August 28, 2023  
Project Number: 05.0045441.12

Re: Response to Comments  
Former Daniel's Mill  
98 East Main Street  
Vernon, Connecticut

On behalf of the Town of Vernon, GZA GeoEnvironmental, Inc. (GZA) has prepared this letter in response to the comments received from the Environmental Protection Agency (EPA) regarding the January 2023 *Notification of Self-Implementing Cleanup* (the Notification) for the former Daniel's Mill property located at 98 East Main Street in Vernon, Connecticut (herein referred to as the Site). These comments were included in a June 22, 2023 electronic transmission from you. For your convenience, the General and Specific comments followed by our responses (in italics) are provided below.

DESIGNED BY: BDR	DRAWN BY: MUS	SCALE: AS SHOWN	4
DATE: 11-16-2022	PROJECT NO. 05.0045441.12	REVISION NO.	SHEET NO.

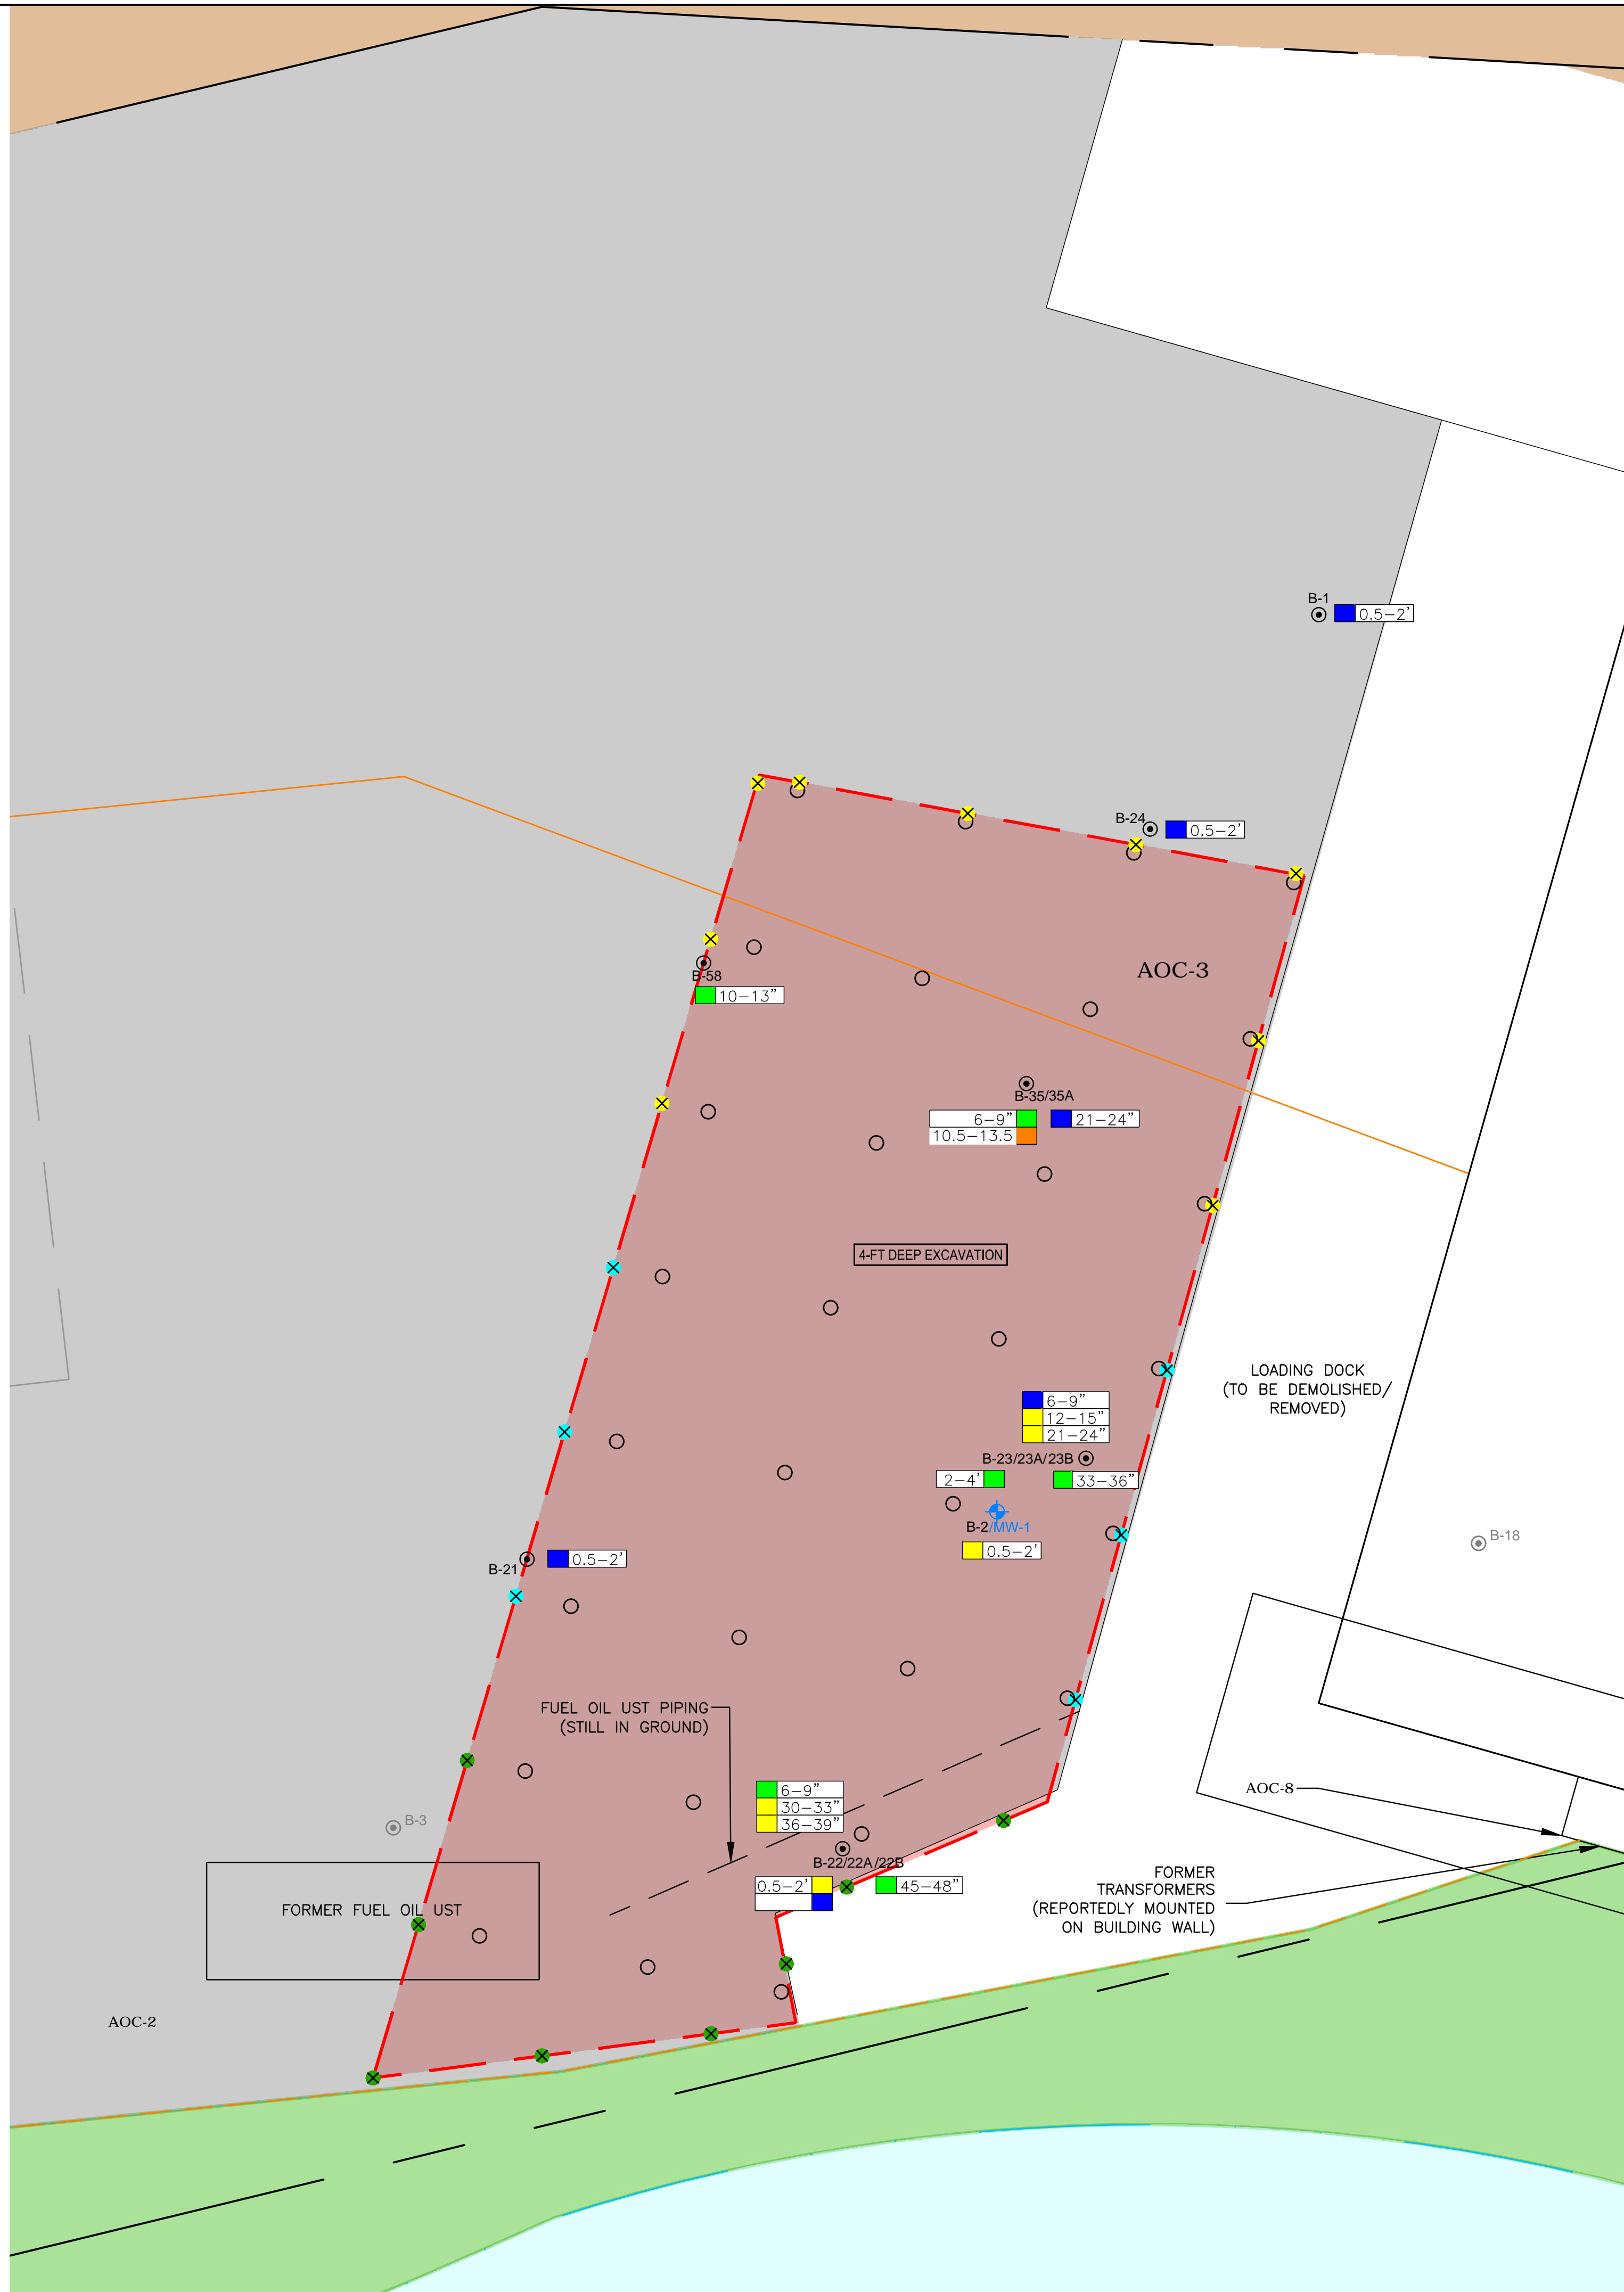
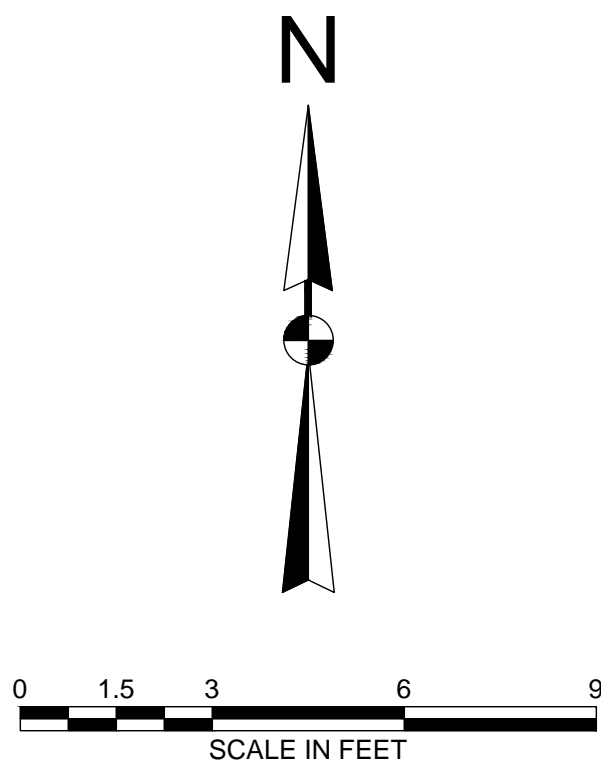
1. Section 3.2, pdf p7. Paragraph 2. It is stated that detected PCB impacts above 1 ppm are bounded laterally to the north and the west of AOC-3. It does not appear to EPA that sufficient sampling has been conducted to establish the northern and western boundaries of AOC-3. Specifically, two of the three samples (B-21 and B-24) were taken over an interval of 0.5- 2 fbg. Sampling over too large an interval can result in dilution, and therefore inaccurate characterization. The third sample, B-58, was taken at 10-13 inches (in). A sample at this very discreet depth may or may not accurately characterize the boundary of AOC-3, as PCBs > 1 ppm have been found in AOC-3 at several depths other than 10-13 in (e.g., 12-15 in, 21-24 in, 30-33 in, 36-39 in, etc.). Please provide additional discussion regarding the adequacy of sampling relative to AOC-3's boundaries, including any plans for future sampling.

*Response: Verification sampling will be completed consistent with a Subpart O grid and, since this grid is more robust than the Subpart N sampling grid, we are confident residual PCB soil concentrations in this area will be less than or equal to 1 mg/kg upon completion of the remedial excavation.*

*With respect to the vertical delineation, PCBs at concentrations above 1 mg/kg were observed in soil at depths up to 36 to 39 inches below ground surface (bgs) in one boring (B-22A) in the southern portion of this AOC and appeared to be limited to depths less than 24 and 33 inches bgs at borings (B-35A and B-23B) in the central and northern portions of this AOC. However, the entire area will be conservatively excavated to 4 feet below grade. Upon excavating to 4 feet below grade, verification soil samples will be collected from the base of the excavation on a grid pattern consistent with Subpart O to demonstrate concentrations are less than or equal to 1 mg/kg. Verification soil sampling locations from the base of the excavation are depicted on Figure 4.*

- *In the northern portion of this AOC, PCBs were only detected above 1 mg/kg in one sample (B-35, 10.5-13.5"). Verification samples will be collected from the sidewalls of the northern portion of the excavation consistent with Subpart O requirements from a depth of 10.5 to 13.5 inches bgs to demonstrate concentrations are less than or equal to 1 mg/kg. Verification soil sampling locations from the sidewalls of the northern portion of the excavation are depicted on Figure 4.*

- *In the central portion of this AOC, PCBs appear to be present above 1 mg/kg in the 6 to 24-inch depth interval. Given this distribution, the verification samples in the central portion of the excavation will be collected consistent with Subpart O requirements and the 12 to 15-inch and 21 to 24-inch interval from each location will be submitted for analytical testing to demonstrate concentrations are less than or equal to 1 mg/kg. Verification soil sampling locations from the sidewalls of the central portion of the excavation are depicted on Figure 4.*

- *In the southern portion of this AOC, PCBs appear to be present above 1 mg/kg from 0.5 to 39 inches below grade. Given this distribution, the verification samples in the southern portion of the excavation will be collected consistent with Subpart O requirements and the 9 to 12-inch, 21 to 24-inch, and 33 to 36-inch intervals from each location submitted for analytical testing to demonstrate concentrations are less than or equal to 1 mg/kg. Verification soil sampling locations from the sidewalls of the southern portion of the excavation are depicted on Figure 4.*

<p>PROJ MGR: BDR          DESIGNED BY: BDR          DATE:</p>	<p>REVIEWED BY: MJS          DRAWN BY: MJS          PROJECT NO:</p>	<p>CHECKED BY:          SCALE: AS SHOWN          REVISION NO.</p>	<p><b>FIGURE</b>  <b>5</b>          SHEET NO.</p>
11-16-2022	05.0045441.12

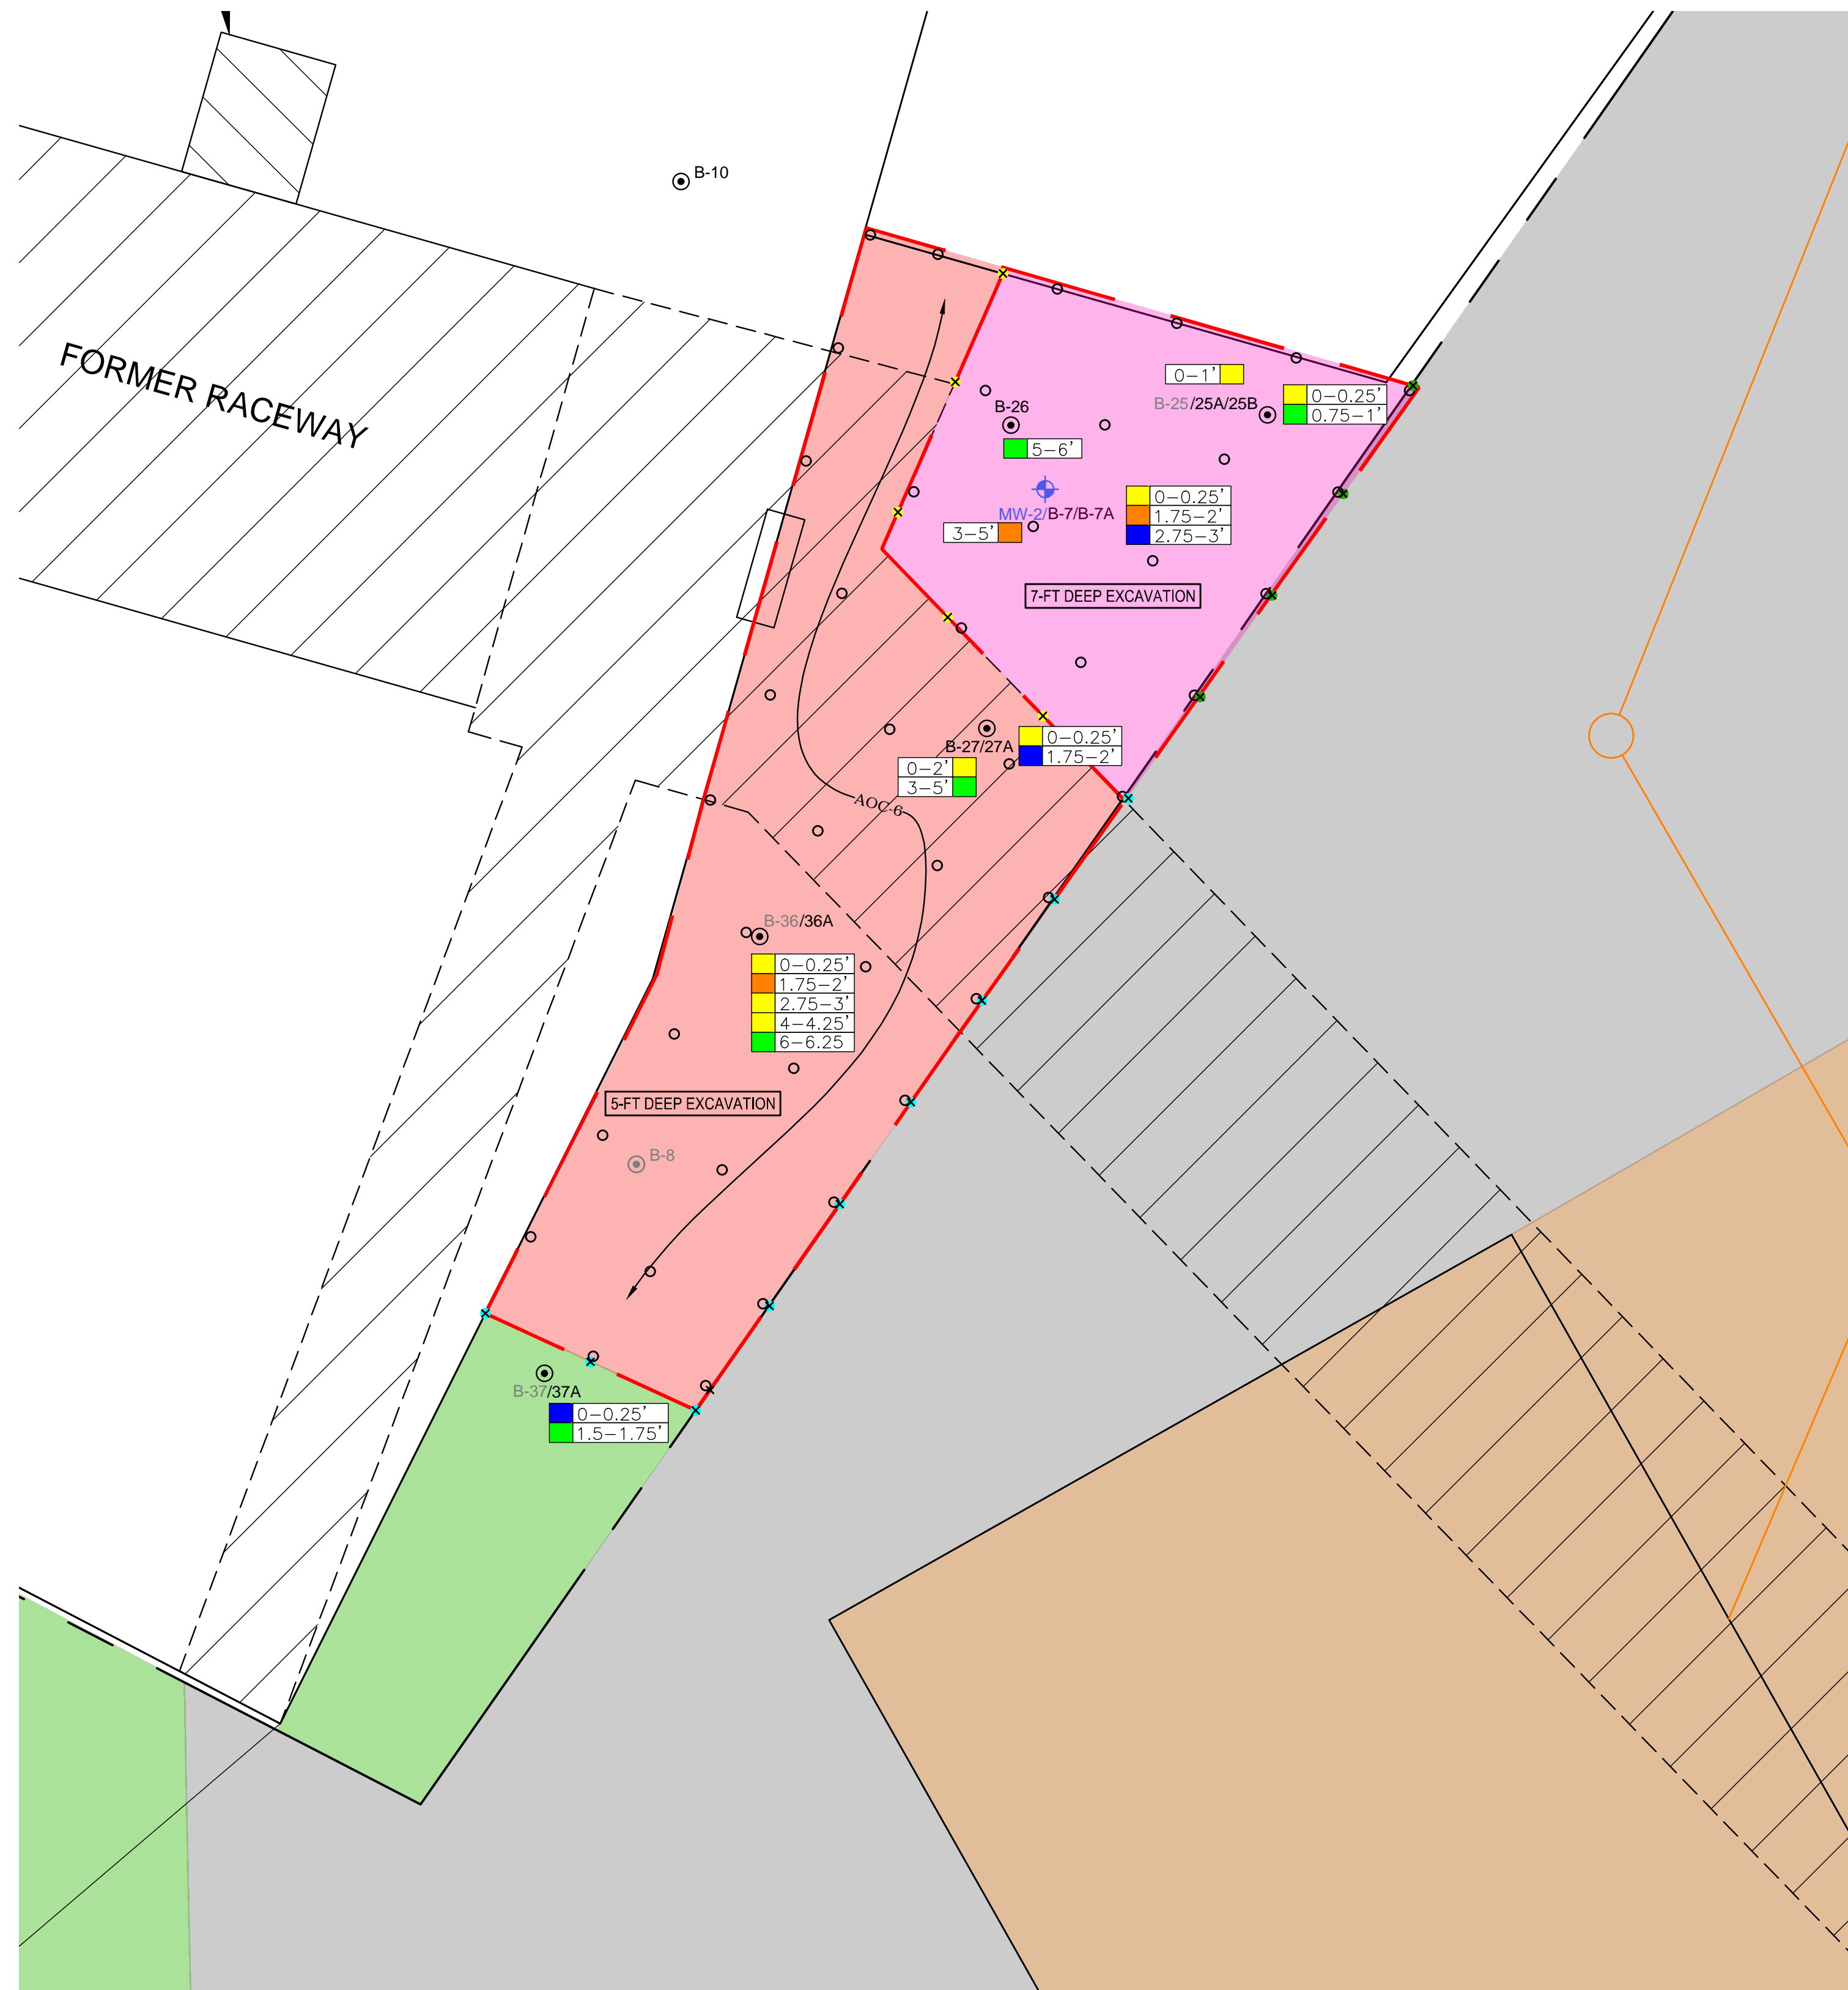
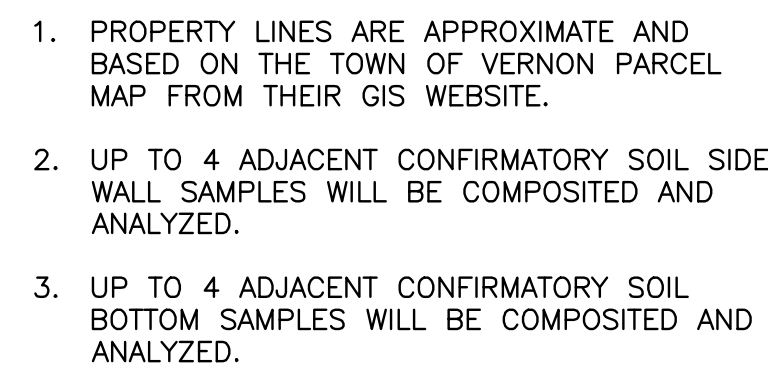
3. Section 3.2, p7. Paragraph 3. It is stated that AOC-6 (east of the building) is bounded to the south by sample B-37A. It is unclear to EPA that this sample adequately defines the southern boundary of this area. Specifically, sample B-37A was taken between 1.5 to 1.75 fbg, and PCBs > 1 ppm have been found deeper than 1.75 fbg throughout the rest of AOC-6 (e.g., at 1.75-2 fbg, 2.75-3 fbg, 4-4.25 fbg, etc.). Please provide additional discussion regarding the adequacy of sampling to determine the southern boundary of AOC-6 east of the building.

*Response: Verification sampling will be completed consistent with a Subpart O grid and, since this grid is more robust than the Subpart N sampling grid, we are confident residual PCB soil concentrations in this area will be less than or equal to 1 mg/kg upon completion of the remedial excavation.*

- PCBs at concentrations above 1 mg/kg were observed in soil at depths up to 2 feet bgs at boring B-27 and up to 4.25 feet bgs at boring B-36A. However, this entire portion of the excavation will be conservatively excavated to 5 feet below grade. Upon excavating to 5 feet below grade, verification samples will be collected from the base of the excavation on a grid pattern consistent with Subpart O to demonstrate concentrations are less than or equal to 1 mg/kg. Verification soil sampling locations from the base of the excavation are depicted on Figure 5.*

- With respect to the horizontal delineation, PCBs were detected in soils from ground surface to 4.25 feet bgs at concentrations above 1 mg/kg. Given this distribution, verification sidewall samples will be collected consistent with Subpart O requirements and the 0 to 0.25-inch, 21 to 24-inch, and 45 to 48-inch intervals from each sidewall sample location will be submitted for analytical testing to demonstrate concentrations are less than or equal to 1 mg/kg. Verification sidewall sampling locations from the 5-foot-deep excavation area are shown on Figure 5. We note that the west and northwestern limits of this portion of the excavation will extend to the building foundation wall and verification sidewall soil samples will not be collected from these areas.*

- In the northern portion of this AOC, PCBs were detected in soil above 1 mg/kg at depths up to 5 feet bgs (MW-2, 3-5'). However, this entire portion of the excavation will be conservatively excavated to 7 feet below grade. Upon excavating to 7-feet below grade, verification samples will be collected from the base of the excavation on a grid pattern consistent with Subpart O to demonstrate concentrations are less than or equal to 1 mg/kg. Verification soil sampling locations from the base of the excavation are depicted on Figure 5.*

- *With respect to the horizontal delineation, PCBs were detected in soils from ground surface to 5 feet bgs at concentrations above 1 mg/kg. Given this distribution, verification sidewall samples will be collected consistent with Subpart O requirements from the following intervals:*
  - *0 to 0.25-inches, 21 to 24-inches, 45 to 48-inches, and 60-63-inches on the east side of the excavation;*
  - *60-63-inches on the south and west sides of the excavation along the interface with the 5-foot-deep excavation; and,*
  - *Verification soil samples will not be collected from the north side of the excavation since the excavation extends to the foundation wall of the building on this side.*

*Verification sidewall sampling locations from the 5-foot-deep excavation area are shown on Figure 5.*
